Project	IEEE 802.16 Broadband Wireless Access Working Group < http://ieee802.org/16 >	
Title	Figure addition to section 14.2.7.3	
Date Submitted	2007-01-11	
Source(s)	Peretz Feder – Alcatel-Lucent Philip Barber - Huawei	pfeder@alcatel-lucent.com , pbarber@huawei.com
Re:		
Abstract	Additional Figures in support of C-NEM-IND(NBR_BS-Update)	
Purpose	Adoption	
Notice	This document has been prepared to assist IEEE 802.16. It is offered as a basis for discussion and is not binding on the contributing individual(s) or organization(s). The material in this document is subject to change in form and content after further study. The contributor(s) reserve(s) the right to add, amend or withdraw material contained herein.	
Release	The contributor grants a free, irrevocable license to the IEEE to incorporate material contained in this contribution, and any modifications thereof, in the creation of an IEEE Standards publication; to copyright in the IEEE's name any IEEE Standards publication even though it may include portions of this contribution; and at the IEEE's sole discretion to permit others to reproduce in whole or in part the resulting IEEE Standards publication. The contributor also ackn

Figure xxx – Primitives flow between 802.16 Entity and NCMS when a MOB_NBR_ADV message is received at the MS

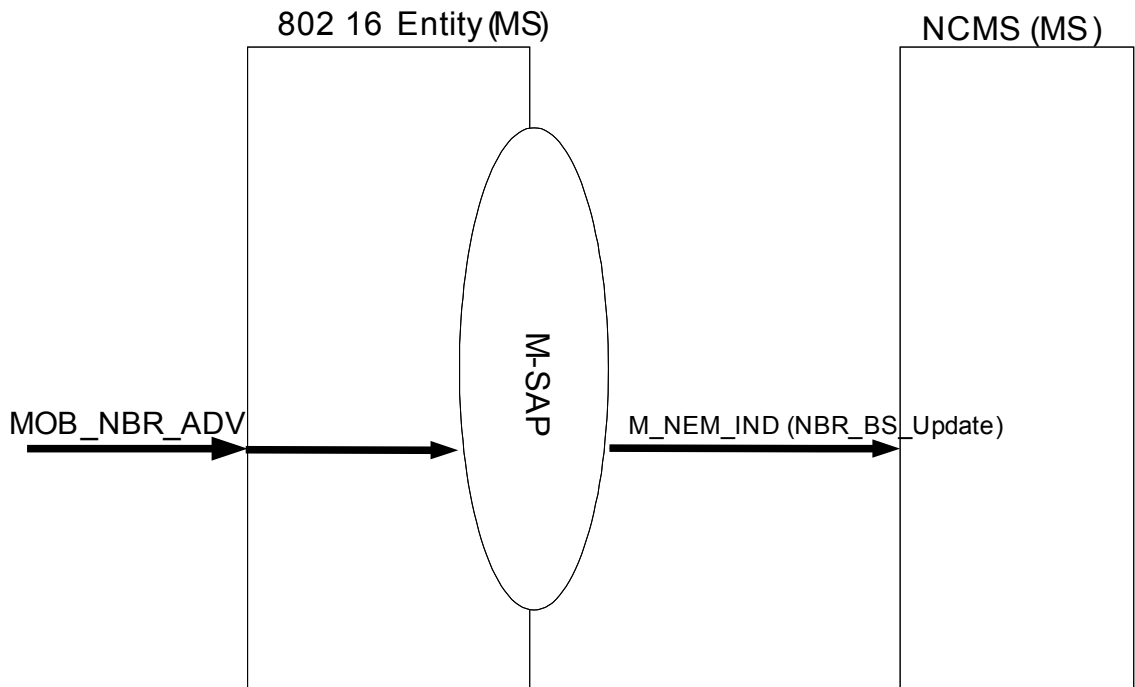
3 Section 14.2.7.3 is missing a drawing showing the interaction of the MS and the NCMS(MS) when a MOB_NBR-
4 ADV is received by the MS. This contribution adds the missing figure and corrects the associated text. (Editorial
5 corrections).

10 This primitive is generated by the MS to notify the NCMS aboutof the reception of a neighbor advertisement
11 (MOB_NBR-ADV) message from the serving BS.
